SECOND AMENDMENT GENERAL PLANNED DEVELOPMENT ST. LUKE'S MEDICAL CENTER 3rd May, 2002

OUTLINE OF MODIFICATIONS TO THE GENERAL PLANNED DEVELOPMENT

ST. LUKE'S MEDICAL CENTER

GENERAL PLANNED DEVELOPMENT

GPD - 5 Change

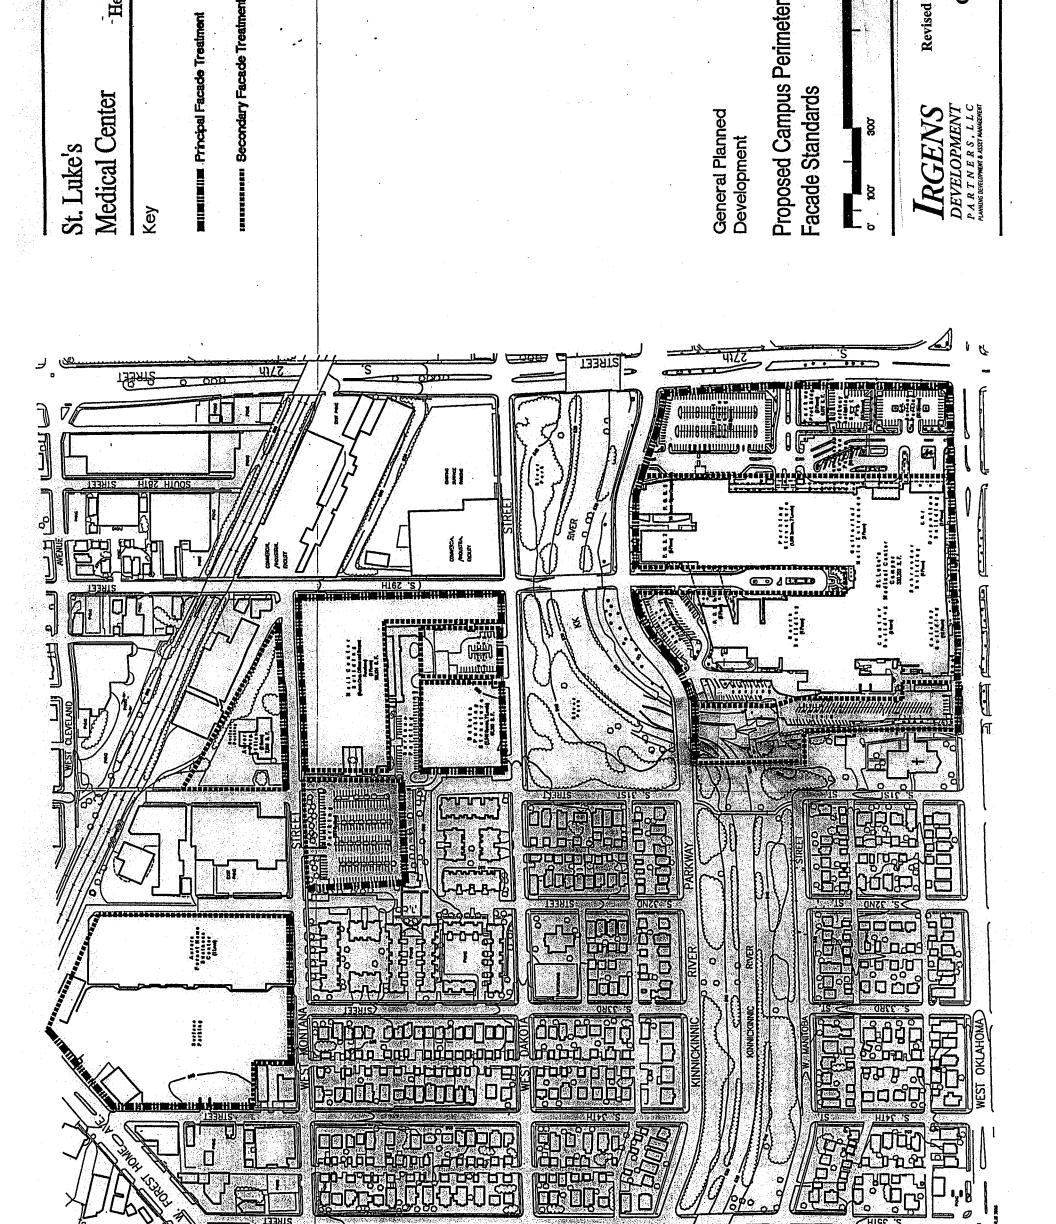
INCREMENTAL CHANGE TO PREVIOUSLY APPRVED SHEET GPD - 5 (Showing incremental changes recorded by this Second Amendment)
